1. The specifications and drawings for Invitation No. DACW64-02-B-0025, Dredging and Marsh Creation, Channel to Liberty at Smith Point in Chambers County, Texas, Trinity River and Tributaries, Texas, advertised 31 May 2002 and for which bids are scheduled to be opened on 11 July 2002 are amended as follows:

BID OPENING DATE IS HEREBY RESCHEDULED FOR 2:00 PM LOCAL TIME, ROOM 175, JADWIN BUILDING, 18 JULY 2002.

In reference to questions from Contractors provided at a Pre-Bid Conference on 25 June 2002; 10:00 A.M., at the Galveston District Office, the following clarifications are provided:

TRINITY RIVER AND TRIBUTARIES, TEXAS
CHANNEL TO LIBERTY AT SMITH POINT
BUS NO.1
Centerline Profiles
6+00 THROUGH 12+00

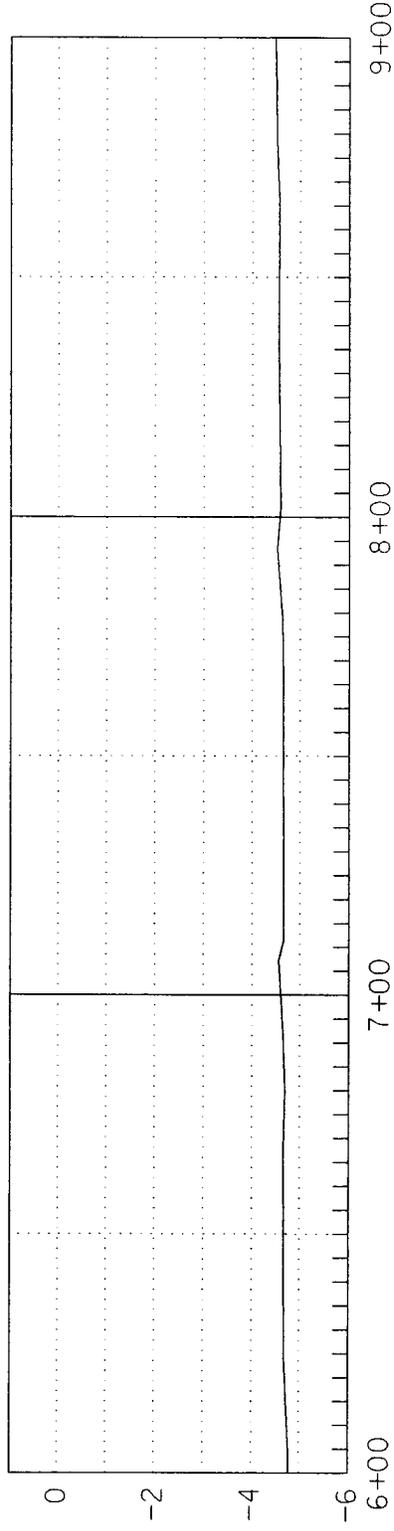
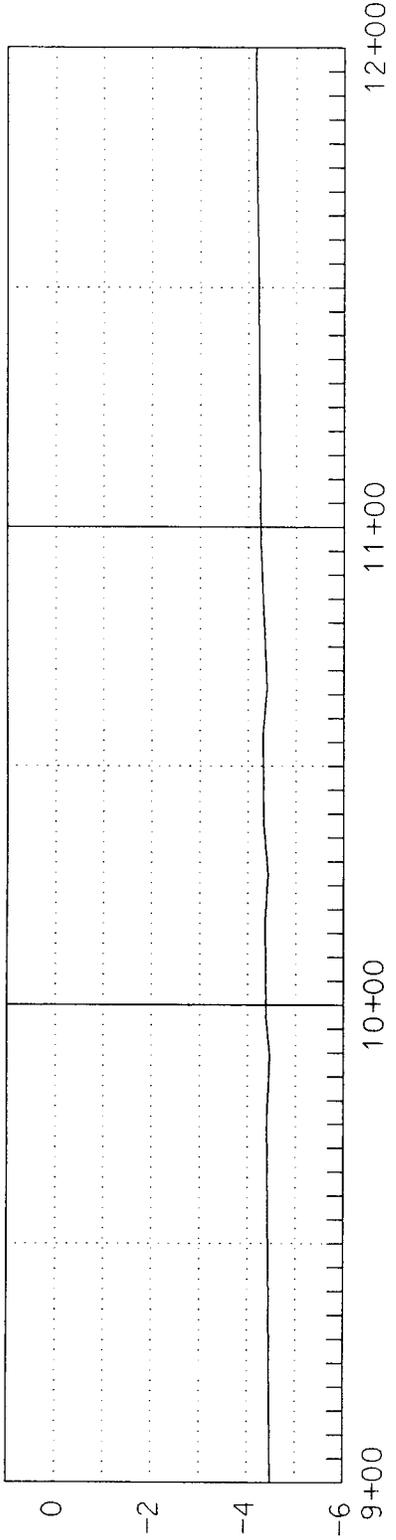
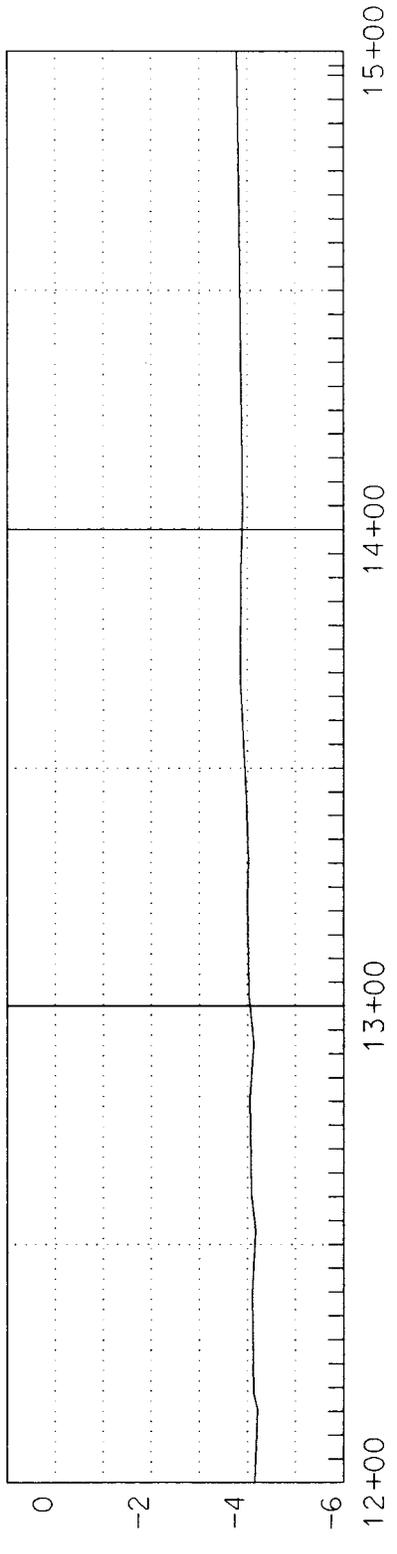
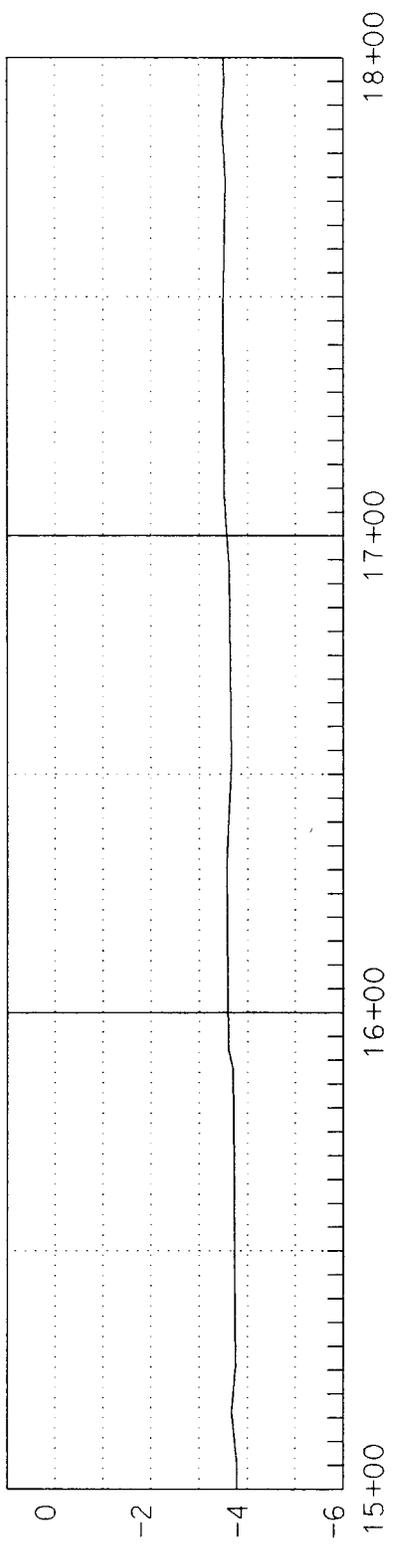
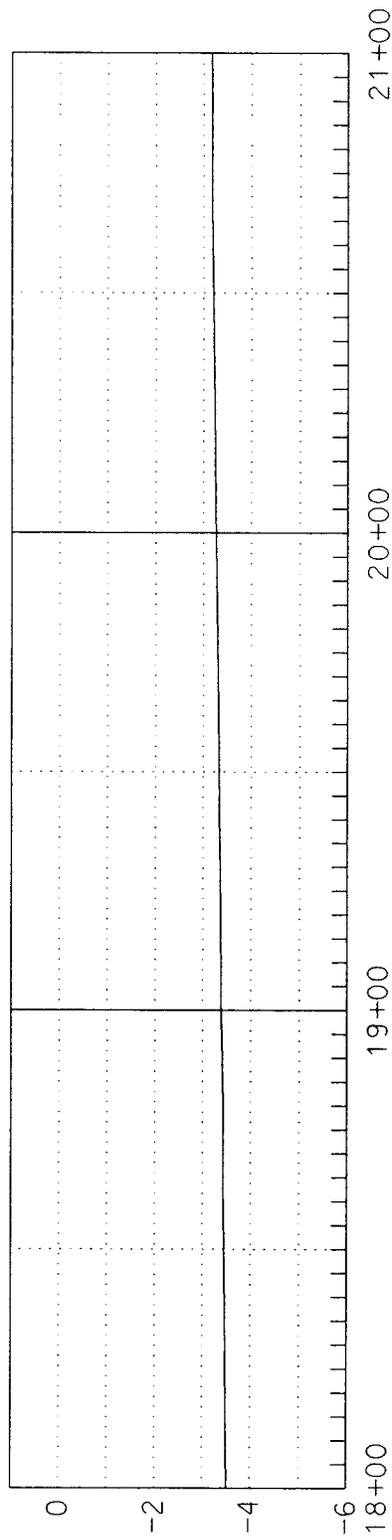
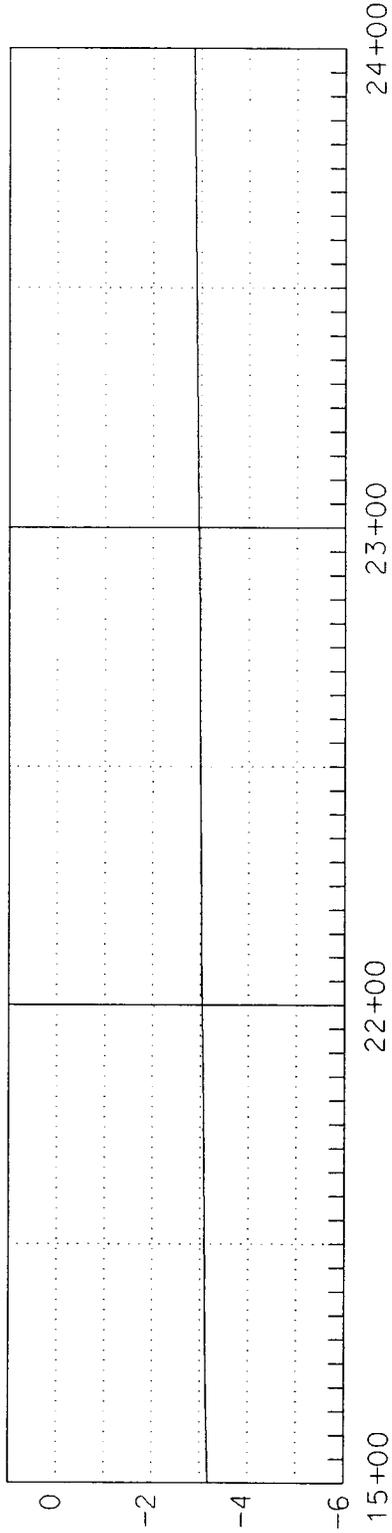
“ You saying there’s a minus 7 elevation. I’m looking at least 3 or 400 foot of a minus 4 elevation in that rock to be placed out into the oyster lease; is that correct?”

A.19 Drawing Sheet 5 of 10 shows depths of (-)7 feet near the southwest corner of the island in Beneficial Use Site No. 1. A centerline profile of the new rock breakwater was obtained June 2002 and a plot of that survey is attached to this amendment on an 8-1/2 by 11-inch sheet. The centerline of the breakwater and the southerly edge of the W. F. Childress oyster lease are 100 feet apart. The breakwater when complete is anticipated to be better than 50 feet from the oyster lease thus no rock, geotextile fabric or other construction material or equipment should touch, enter or fall into the lease area during or after construction.

(1) SKETCHES 1 Through 4. - The enclosed new Sketches 1 through 4, showing the centerline profile of BUS No. 1 shall be attached to and become part of this Invitation.

TRINITY RIVER AND TRIBUTARIES, TEXAS
 DREDGING AND MARSH CREATION
 CHANNEL TO LIBERTY AT SMITH POINT
 BUS NO.2
 CENTERLINE FROM
 0+00 THROUGH 9+00

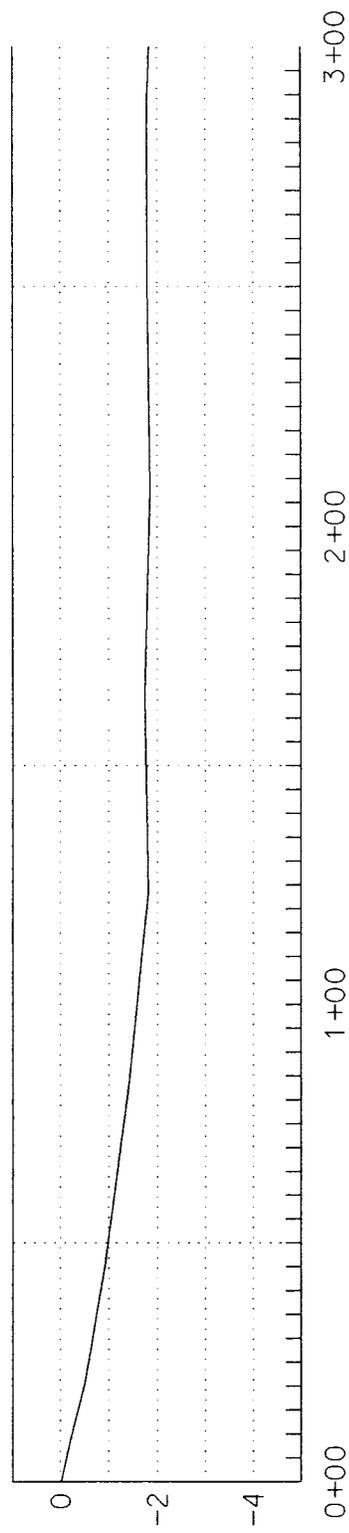
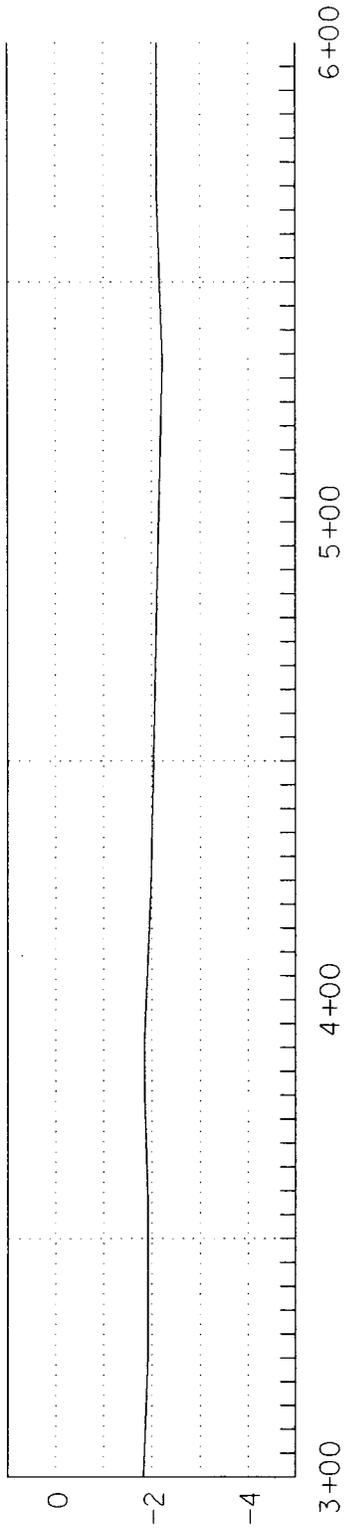
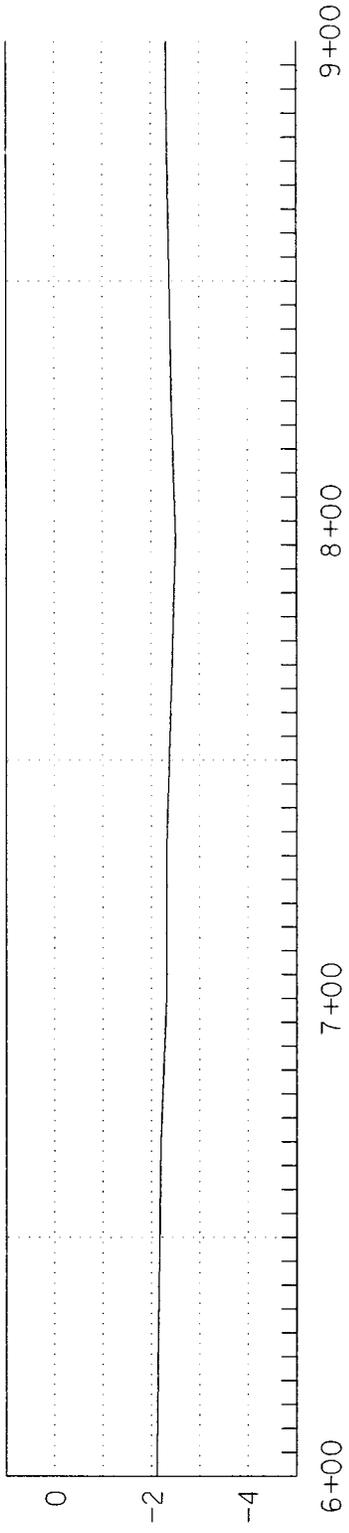
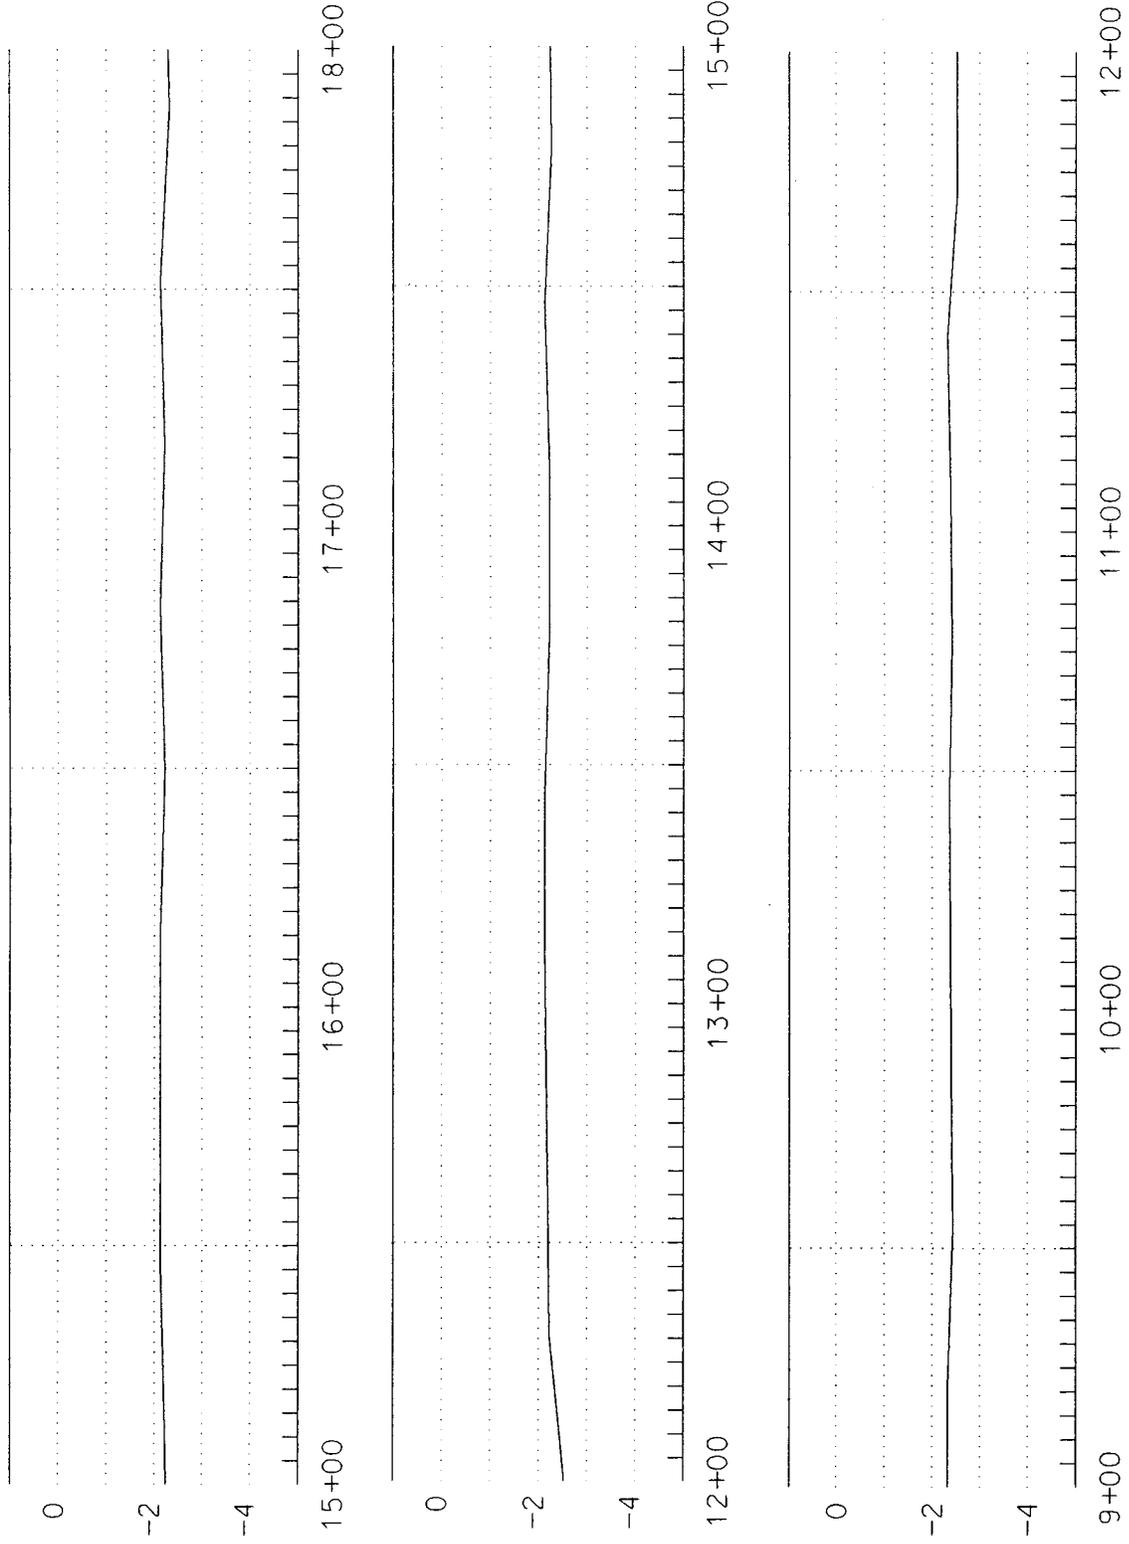
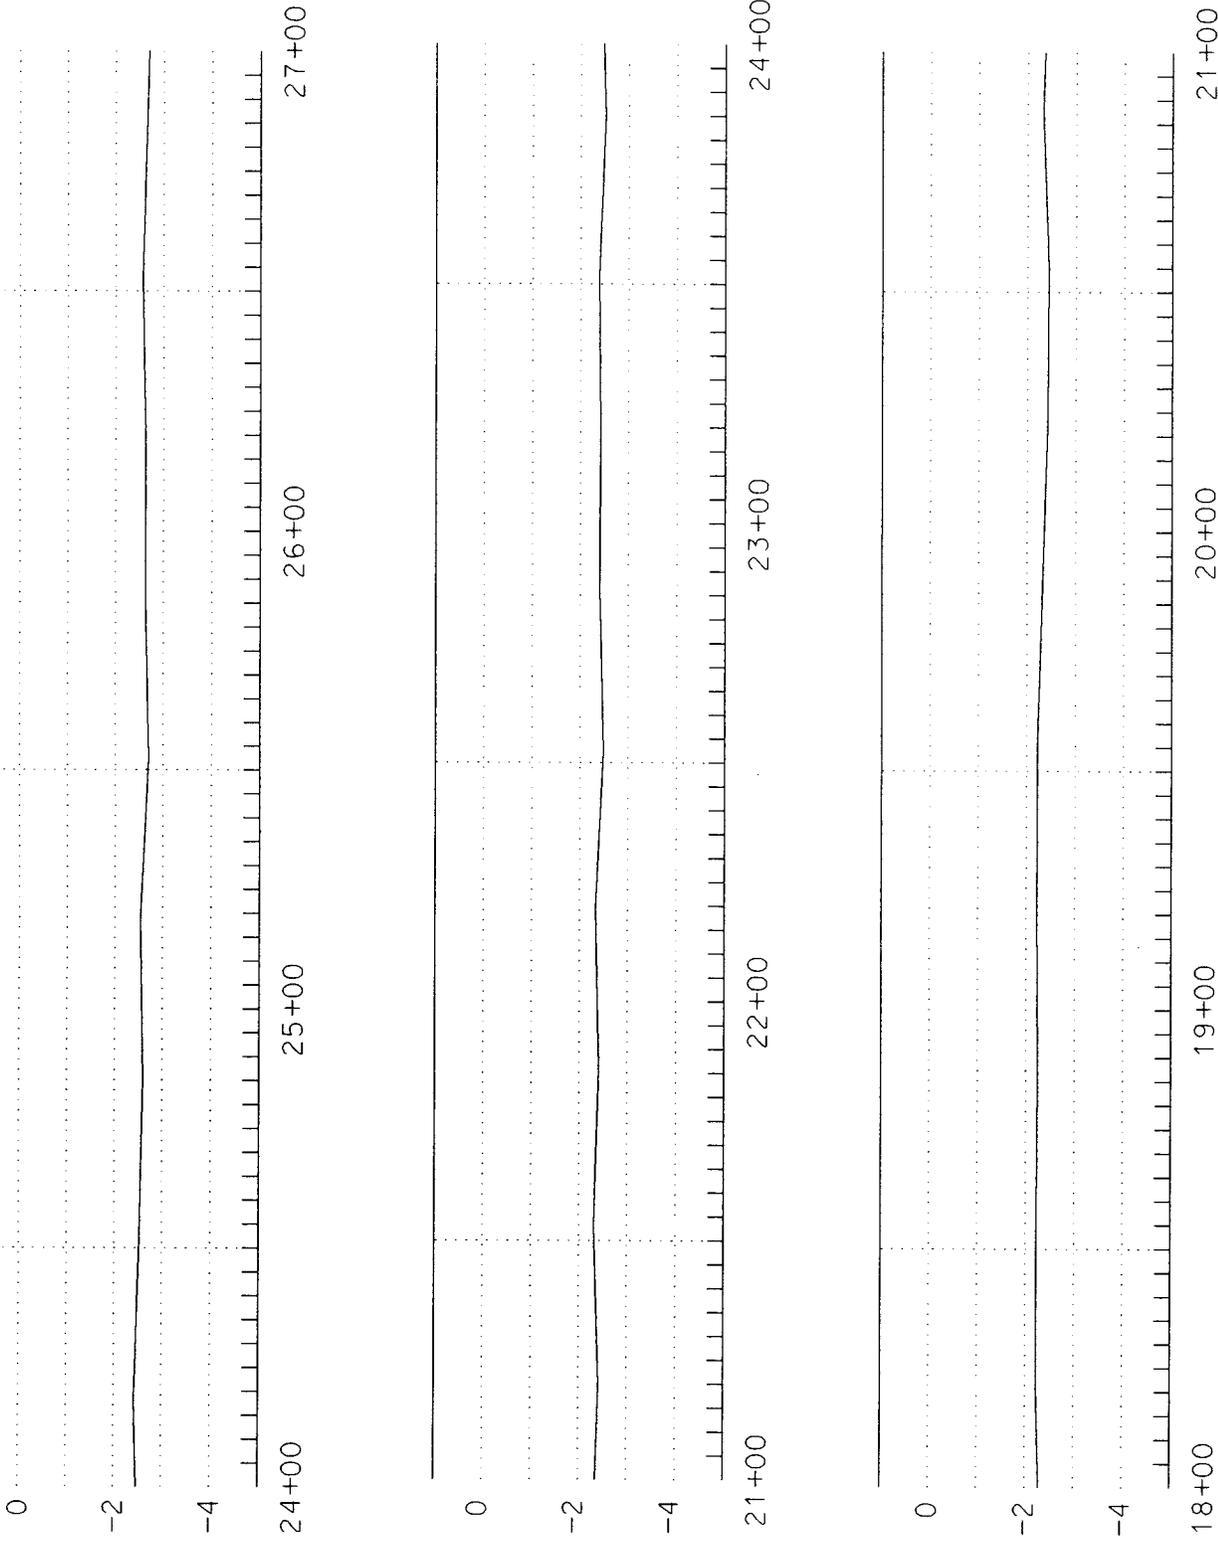
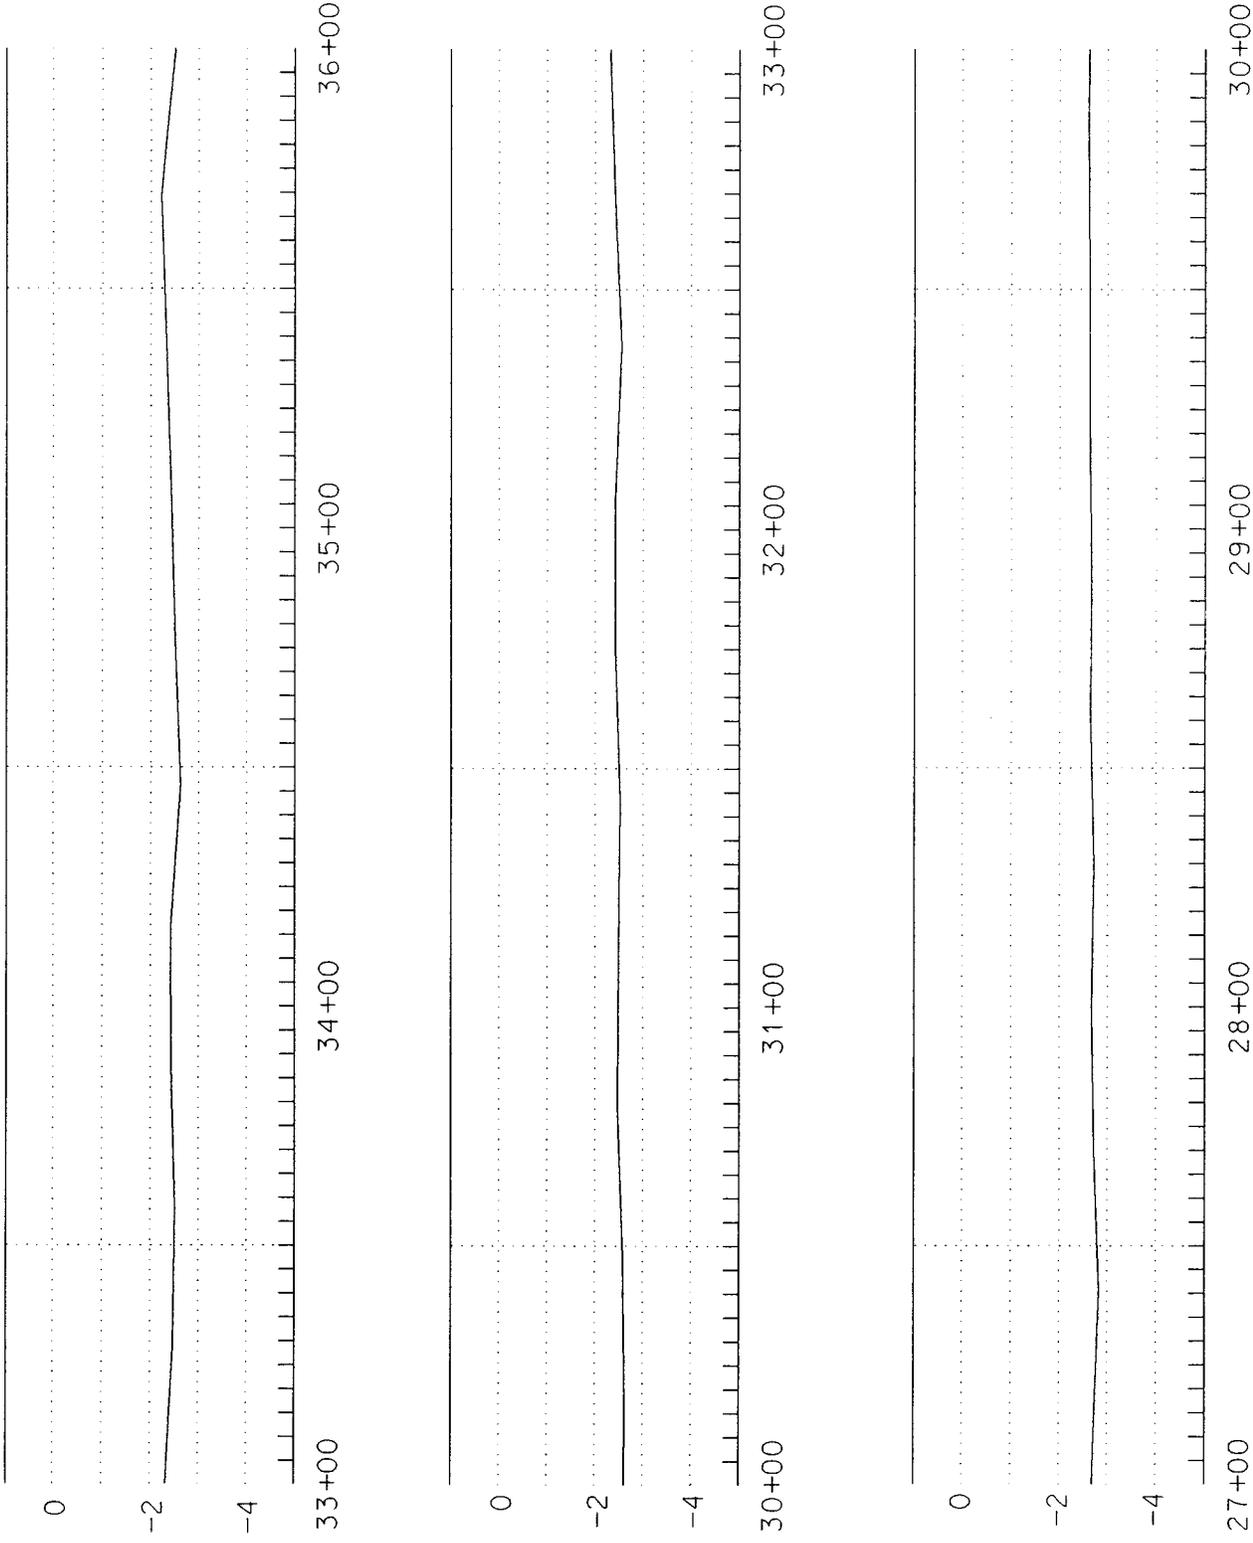
Q.24 Question No. 24 deals with two main concerns: designing the tubes and access to the work sites.

“And then we’ve got contractors - - the Government just said they don’t have any idea how to get this rock in. That’s what I just heard, so is it my understanding that we design how we get rock from minus 7 to minus 4, and comply with the cross section design that’s in the specs?”

A.24 Yes. Best information available shows elevations of (-)7 feet MLT or deeper approach the construction area; however, the depth along the construction alignments (see centerline profiles attached to this amendment for both the rock breakwater in Beneficial Use Site No. 1 and the geotextile tube containment structure and the earth/shell levee with geotextile tube in Beneficial Use Site No. 2) vary from minus to positive.

(2) SKETCHES 5 Through 12, - The enclosed new Sketches 5 through 12, showing the centerline profile of BUS No. 2 shall be attached to and become part of this Invitation.
